Date Created: 12/22/2003
Date Issued: 1/20/2004
PCN # 20035102

INFORMATION ONLY NOTIFICATION

PCN Type: Marking Format or Content

Change From: DO-35

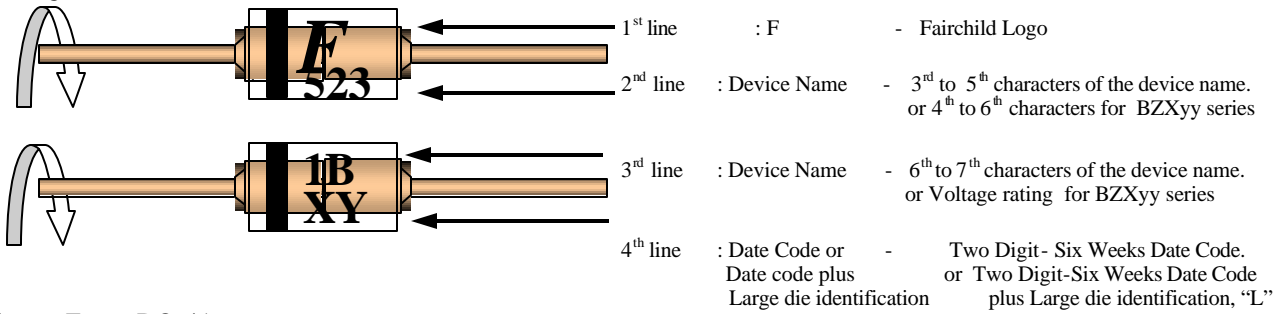
Date code marking will be implemented to improve the traceability of the parts. This additional marking content will ensure a fast turn-around of historical problem verification, better control for containment actions and improve visibility of implementation dates for corrective actions.

The following revisions will be implemented:

Change To: DO-35
